PREVOST

**SAFETY
RECALL**

Sr08-12

DATE : OCTOBER 2008	SECTION : 23-ACCESSORIES
SUBJECT : REPLACING WEAKENED BOLTS ON THE ROOF ESCAPE HATCH

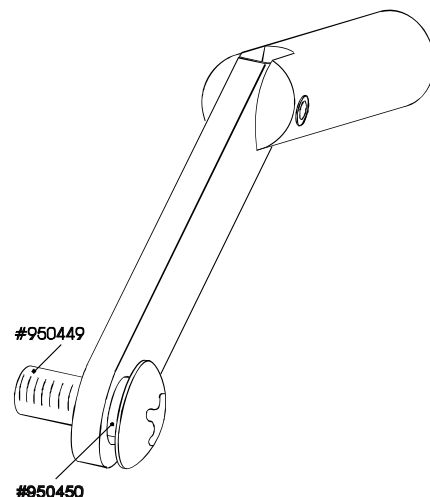
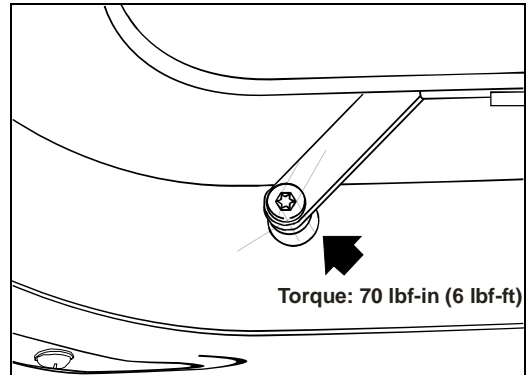
On the vehicles mentioned above, it is **absolutely necessary** to replace weakened bolts on the roof escape hatch. The roof escape hatch manufacturer encountered a quality issue related to the bolt's installed strength. Bolts exposed to higher than normal torques were used in the manufacturing of the escape hatches. Weakened bolts can fracture during opening of the hatch for ventilation. The hatch can detach completely, causing injuries, damages to nearby vehicles and even cause a crash.

4. Insert the new bolt #950449 into the bushing #950450.
5. Insert the bolt and bushing into the hole in the linkage. Hand tighten the bolt into the threaded brass insert.
6. Tighten new bolt and bushing to a torque of **70 lbf-in (6 lbf-ft)**. Use a screwdriver bit Torx T40. Loctite is not needed for the new installation.

When tightening the bolt, hold the linkage over the bushing and against the head to ensure correct alignment.
